STATE OF TENNESSEE
DEPARTMENT OF TRANSPORTATION
BUREAU OF ENGINEERING

I-65 INTERCHANGE AT BUCKNER ROAD
IN SPRING HILL (DESIGN-BUILD)

REV. 09/14/20: REVISED INDEX OF SHEETS.

TYPE	YEAR	PROJECT NO.	SHEET NO.
FUNCT.	2020		18

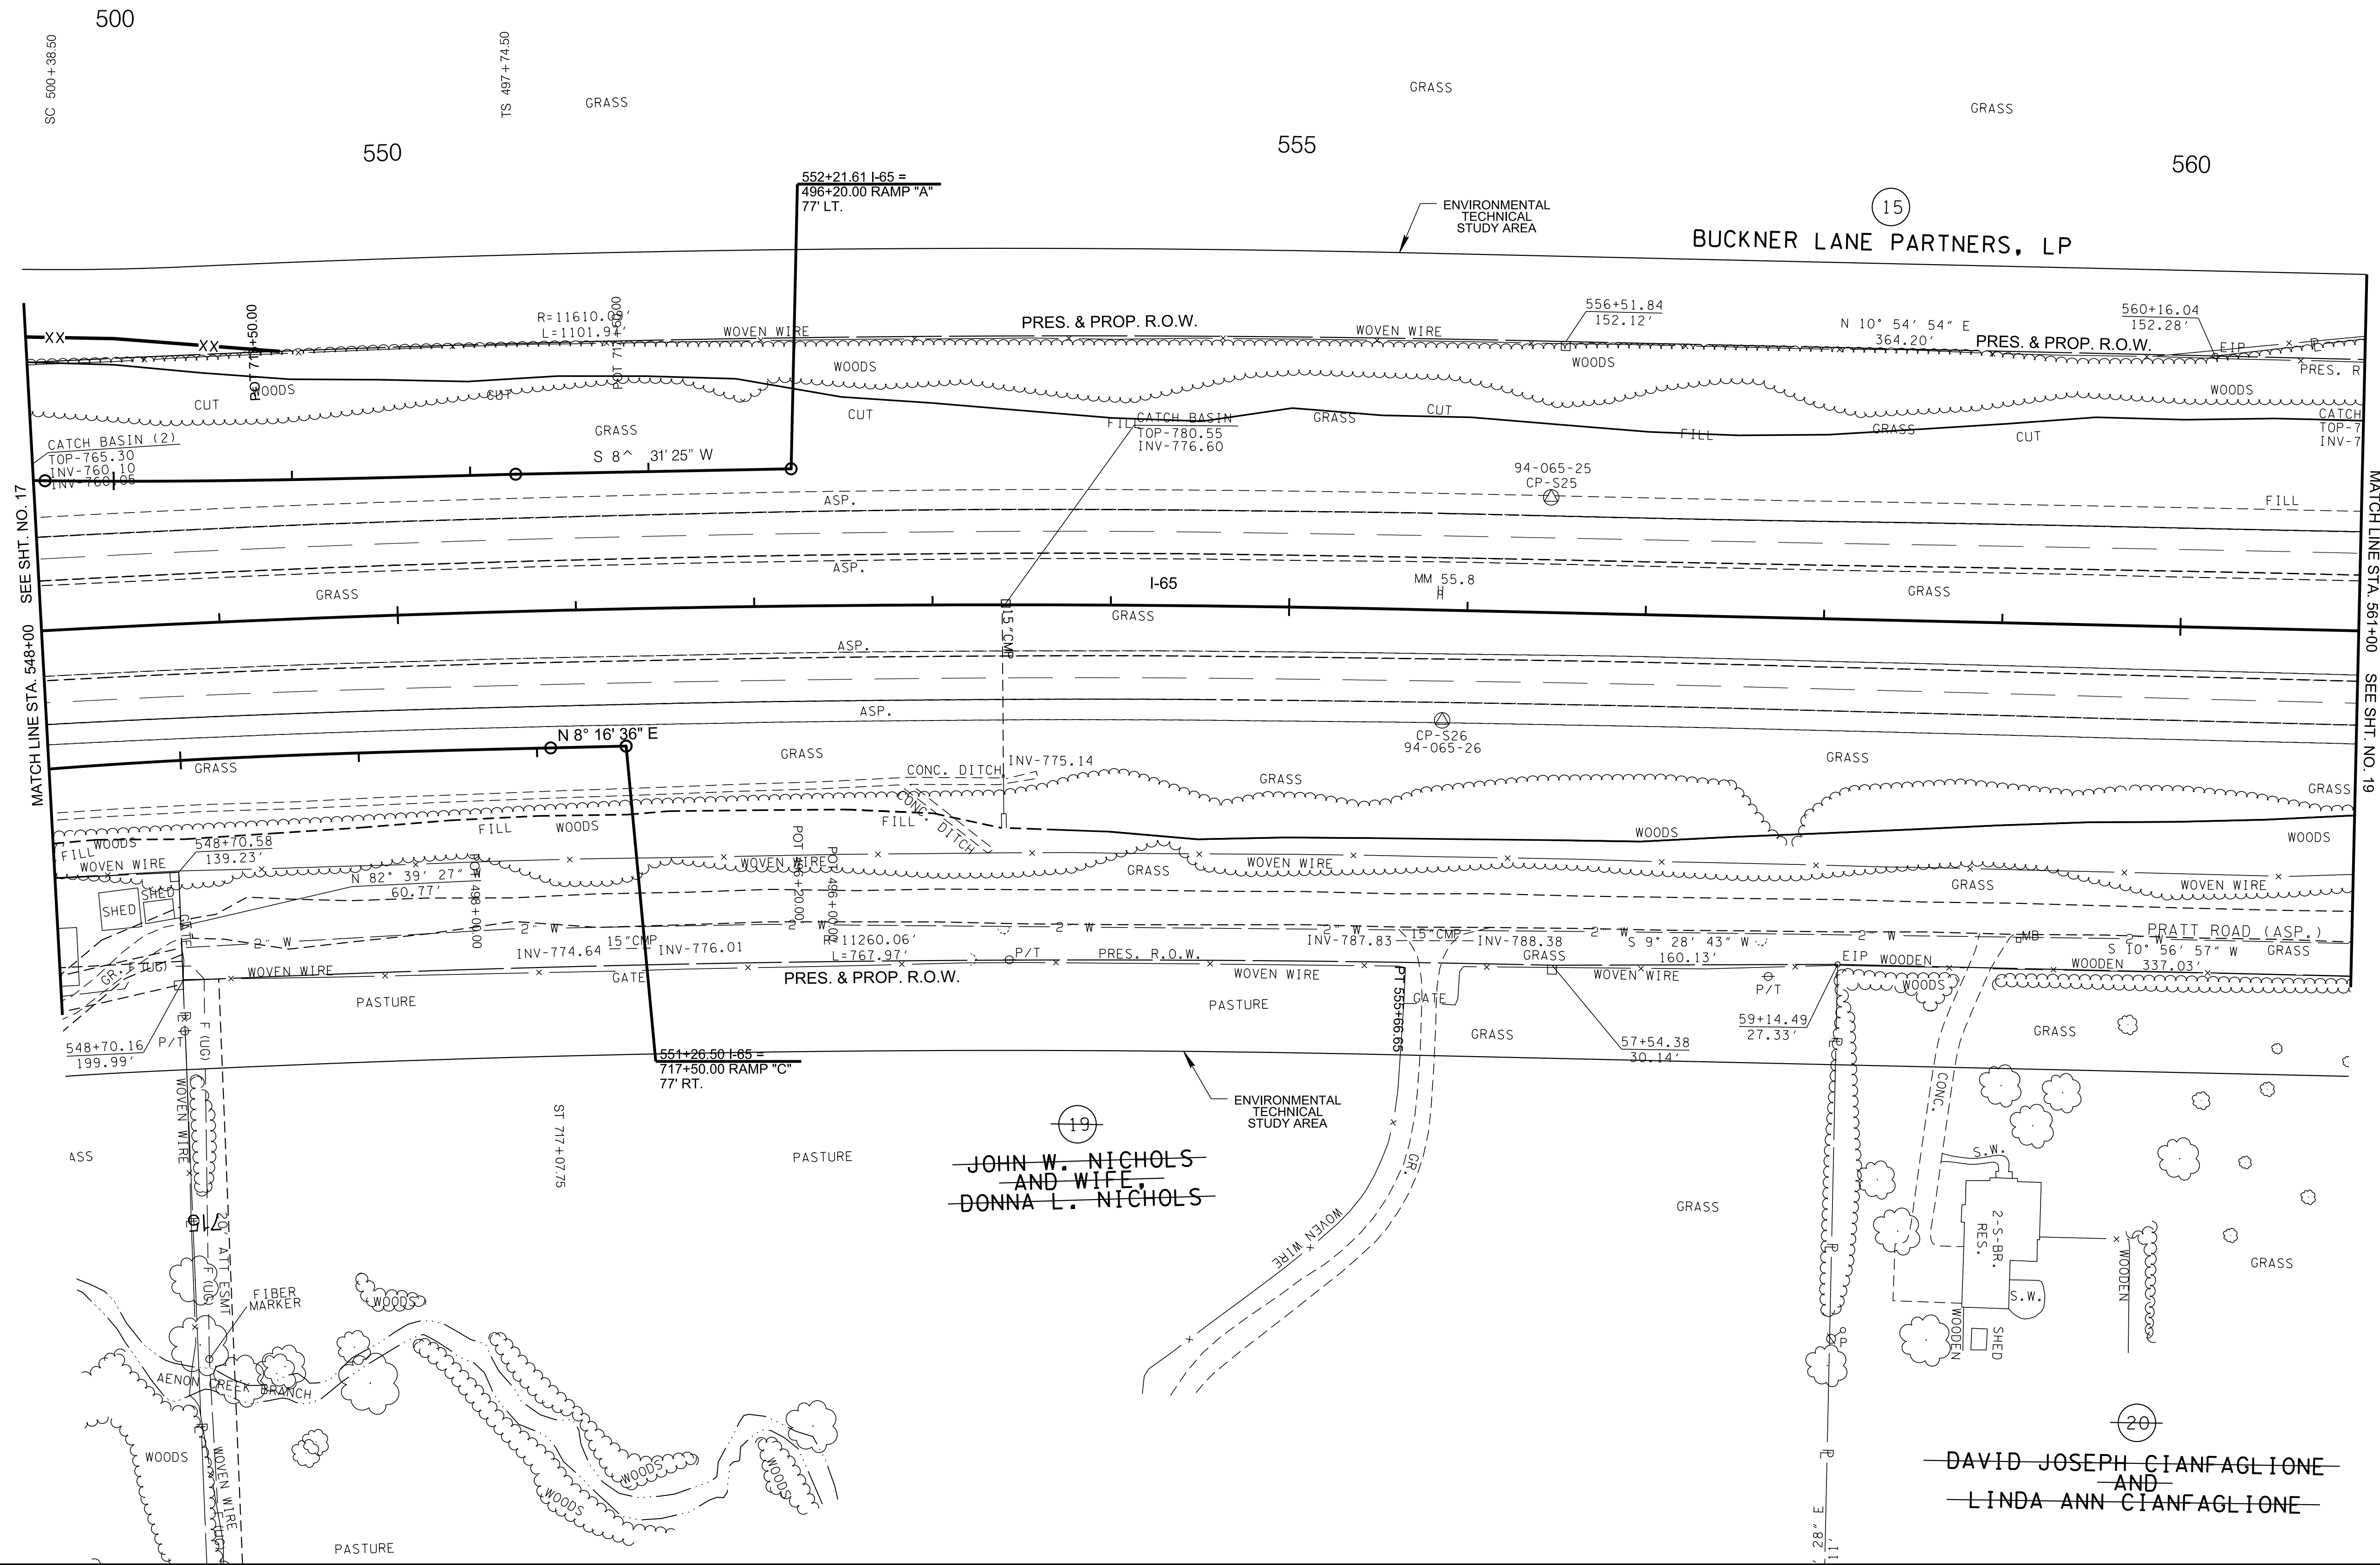
REV. 09/14/20: REVISED RAMP A ALIGNMENT.
ADDED 15' CMP EXTENSION AT STA. 553+39.09.

TYPE	YEAR	PROJECT NO.	SHEET NO.
FUNCT.	2020		18A

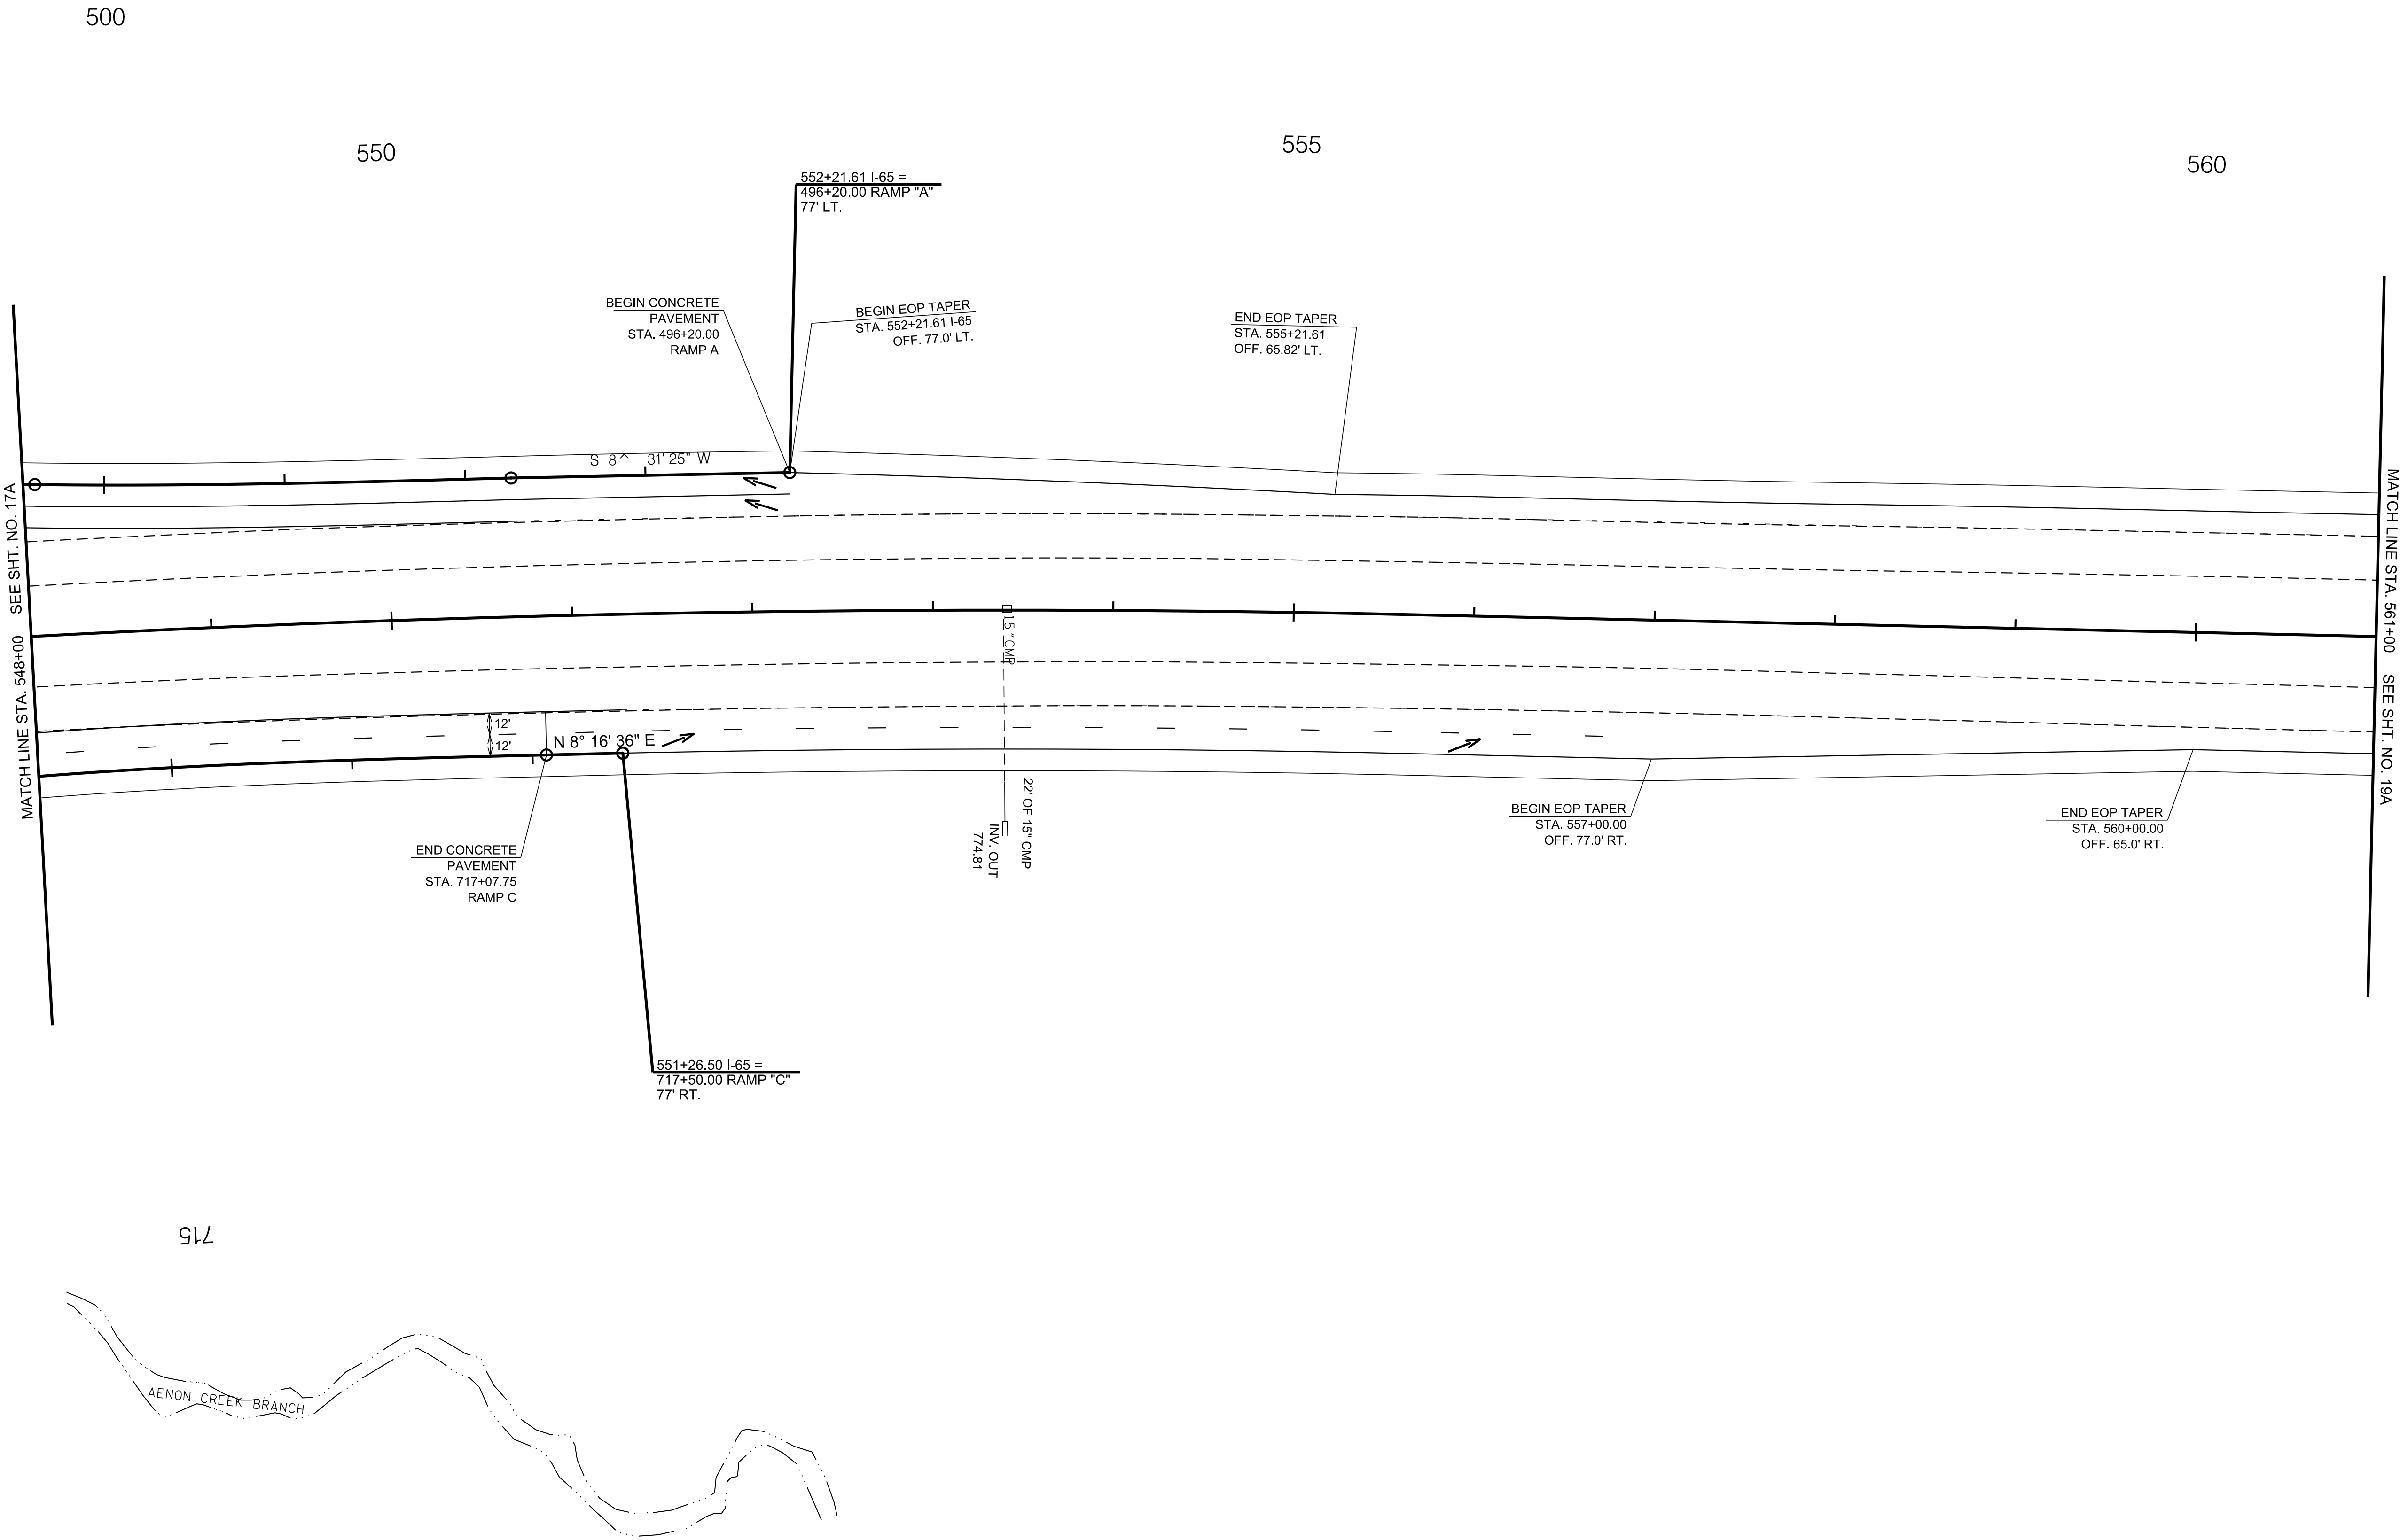
REV. 09/14/20: REVISED RAMP A ALIGNMENT.
ADDED 15' CMP EXTENSION AT STA. 553+39.09.

TYPE	YEAR	PROJECT NO.	SHEET NO.
FUNCT.	2020		19

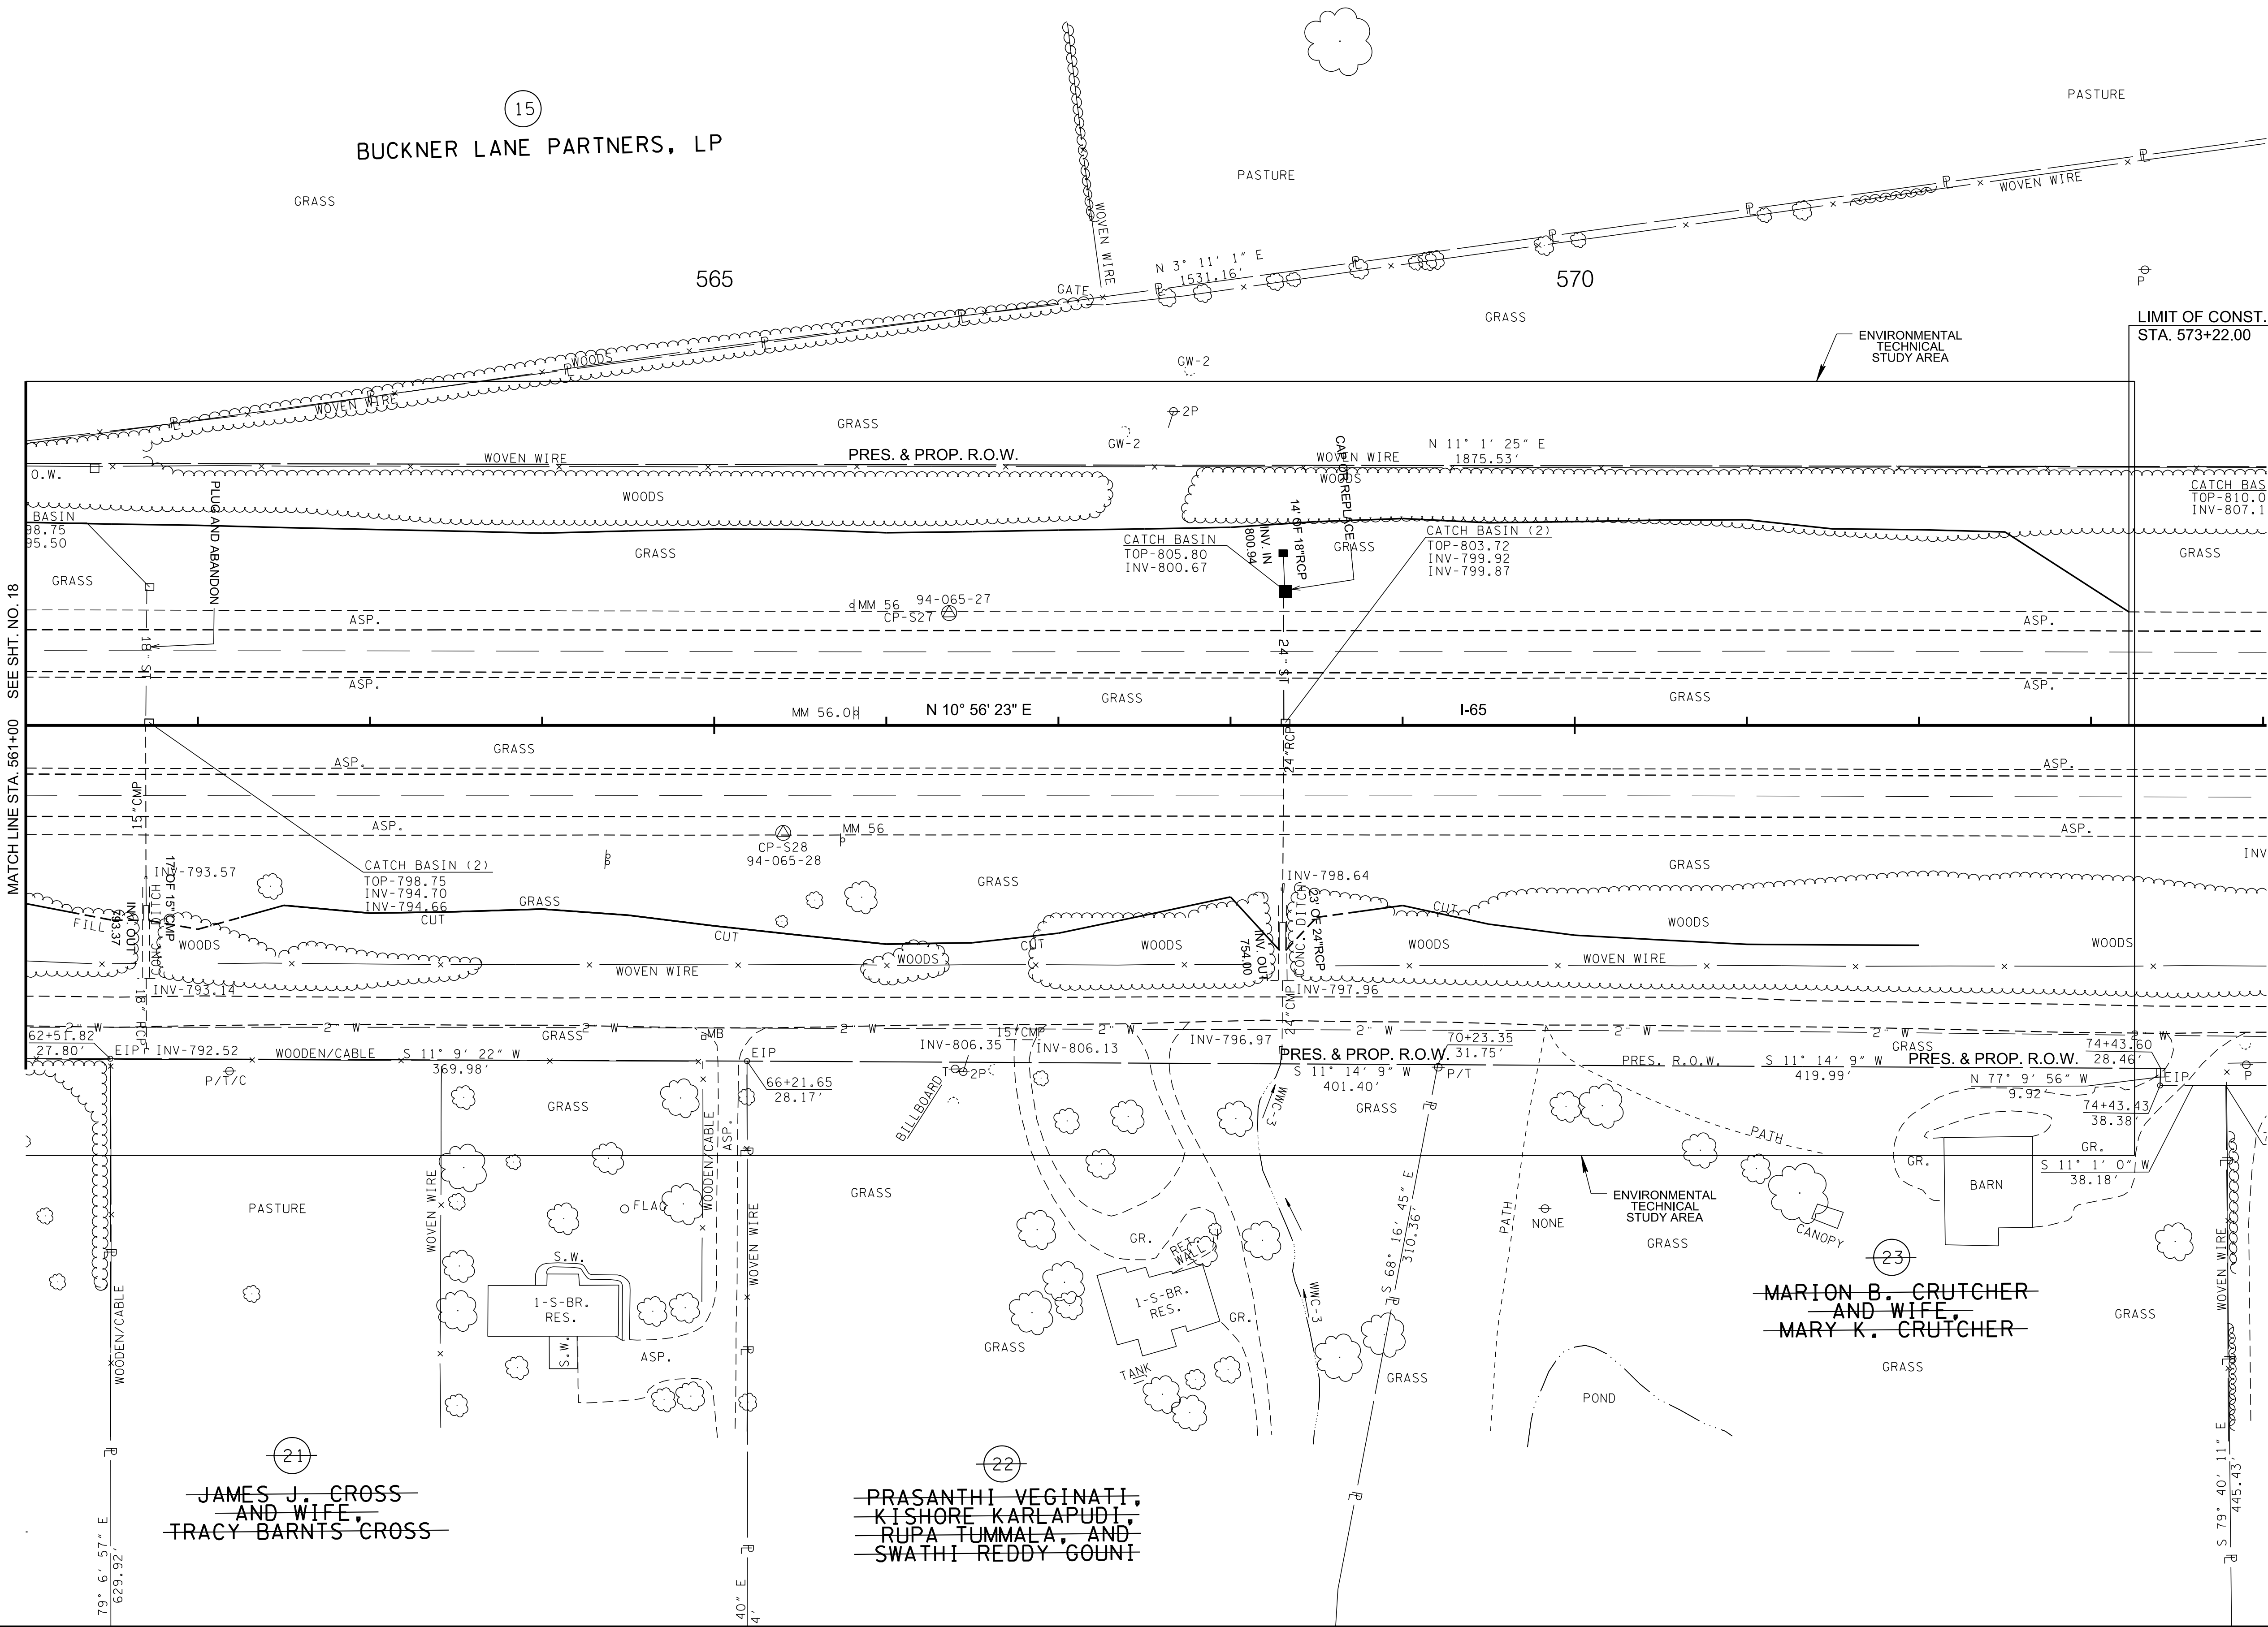
REV. 09/14/20: REVISED LIMIT OF CONSTRUCTION.
ADDED 18" RCP AND 24" RCP AT STA. 561+70.28.
REVISED SHEET NUMBER.
